MINUTES FROM TECHNICAL REVIEW COMMITTEE MEETING 23 AUGUST 1989 NCBC  
GULFPORT MS  
10/5/1989  
NCBC GULFPORT

CBC GULFPORT  
TECHNICAL REVIEW COMMITTEE MEETING MINUTES  
23 AUGUST 1989

*PHASE II*  
COMMENTS FOR THE FINAL VERIFICATION REPORT  
NAVAL CONSTRUCTION BATTALION CENTER (NCBC)  
GULFPORT, MISSISSIPPI

We have recently reviewed the Final Verification Report for the Naval Construction Battalion Center (NCBC) located at Gulfport, Mississippi. The purpose of this review is to evaluate the analytical data and recommend additional work that will satisfy the requirements under the Comprehensive Environmental Response Compensation and Liability Act (CERCLA). Six sites are included in this study and include a fire fighting training area, a disaster recovery disposal area, and four other landfill/disposal areas. Figure 1 shows the location of these sites and table 1 lists the chemical parameters identified for analysis of sediment, soil, and water samples at NCBC for this study.

GROUNDWATER MONITORING WELL AND  
SAMPLING LOCATIONS - SITE 5

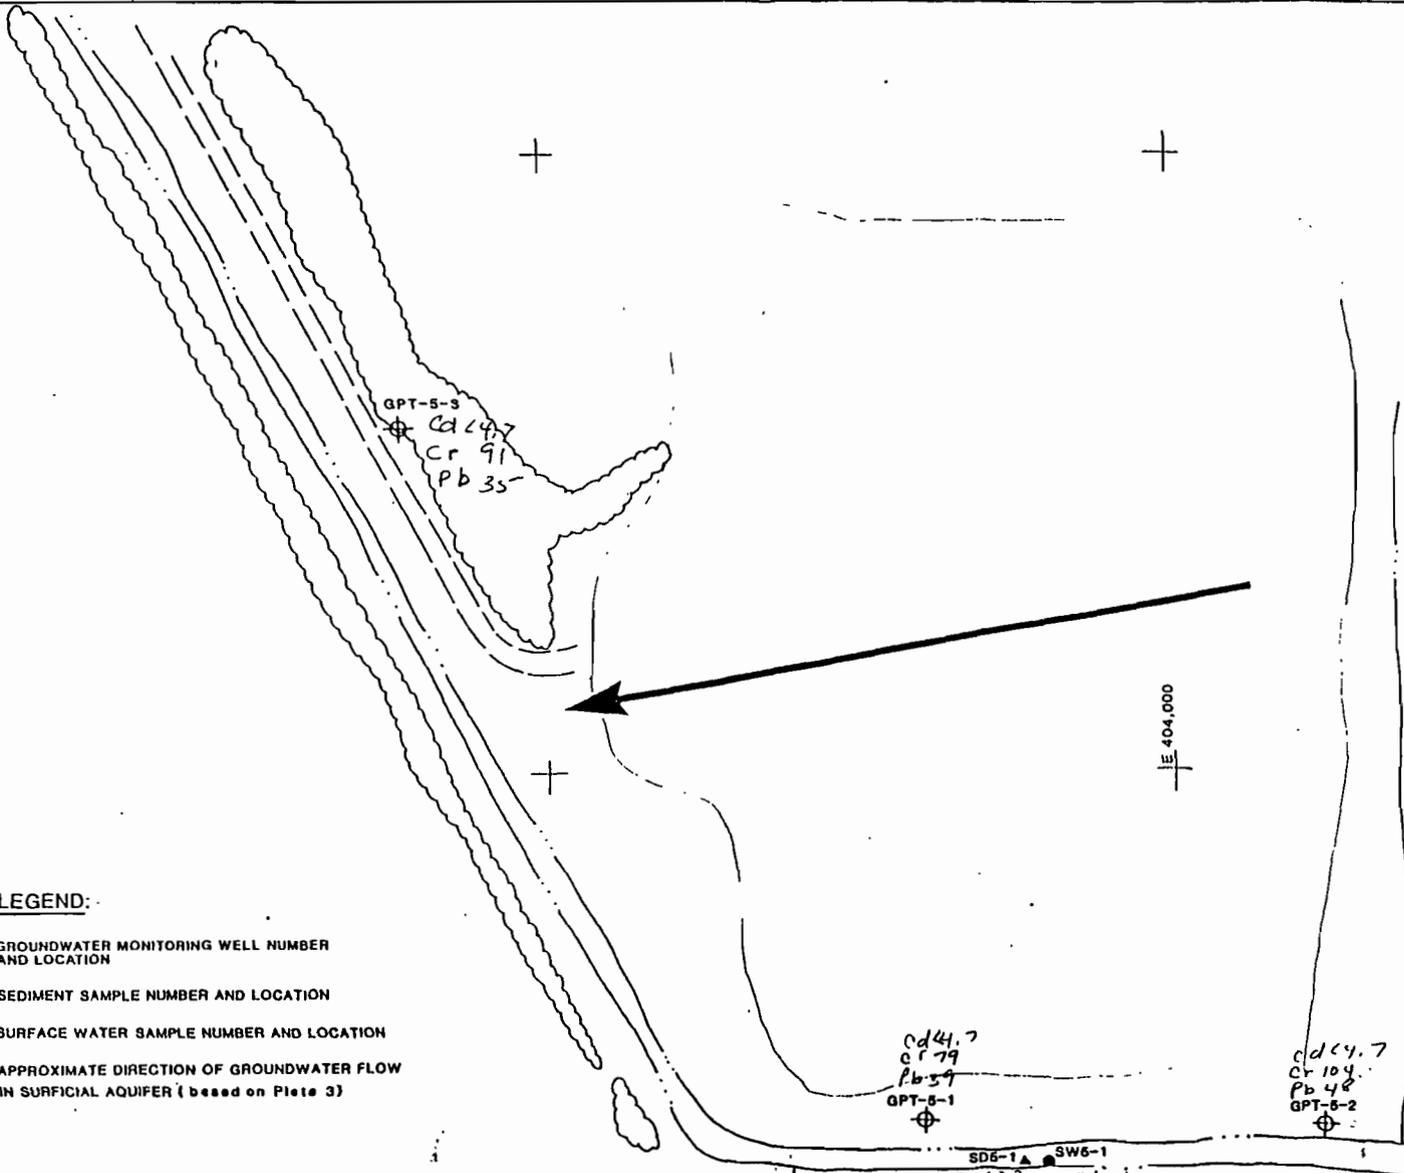
Elevated levels of chromium were detected at Site 5 (figure 7). Analytical results for groundwater samples from GPT-5-1, GPT-5-2 and GPT-5-3 indicate chromium concentrations of 79 ppb, 104 ppb, and 91 ppb, respectively. Lead levels were all below the MCL, but are high enough (38 to 48 ppb) to be of concern. As for the other sampling sites, resampling as recommended in the report should be done, but in a manner that reduces the dilution of groundwater samples. Additional downgradient wells are needed.

As at Site 4, the disposal of MEK is of concern and should be added to the list of chemical parameters analyzed for in future sampling events.

**GROUNDWATER MONITORING WELL AND SAMPLING LOCATIONS - SITE 6**  
NCBC Gulfport  
Gulfport, Mississippi

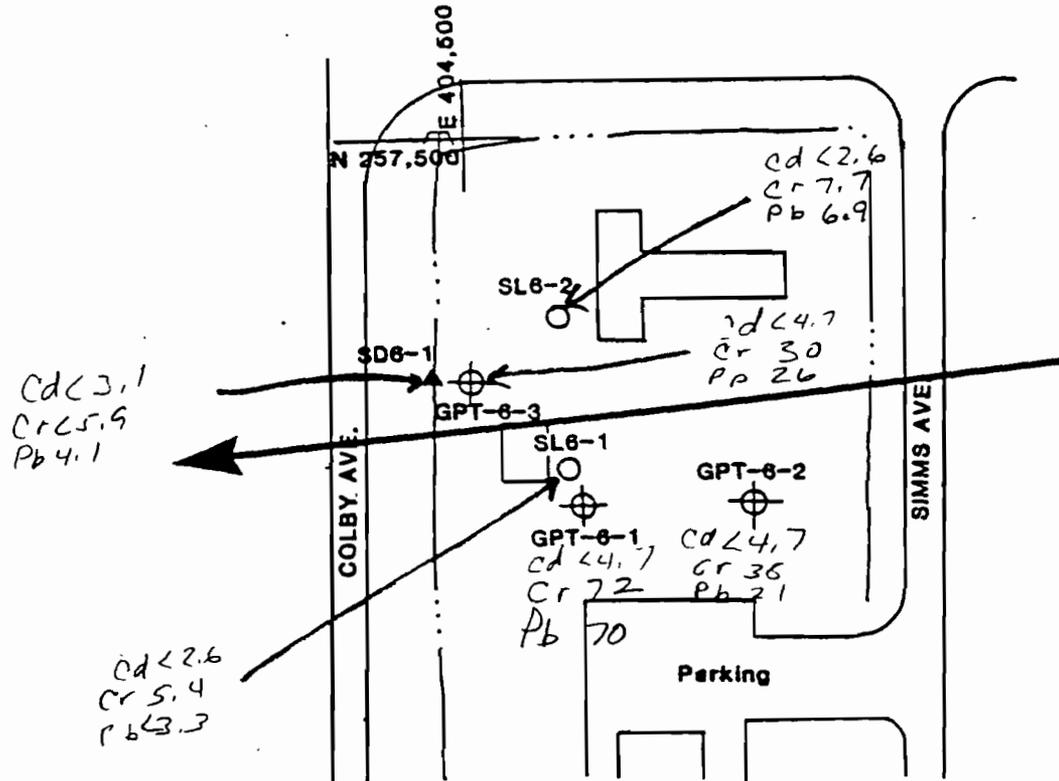
The concerns at Site 6 are much the same as those at Sites 4 and 5 (figure 8). Concentrations of chromium and lead in GPT-6-1 are 72 ppb and 70 ppb, respectively. Levels of these two metals are below the MCL of 50 ppb in each of the other two monitoring wells, but they are high enough to be of concern. As stated previously, sampling of discrete intervals is recommended to confirm the level of contamination and to determine if there is vertical variations in their concentrations.

The disposal of MEK at this site makes it necessary that it be included in the list of chemical constituents analyzed for in future sampling events.
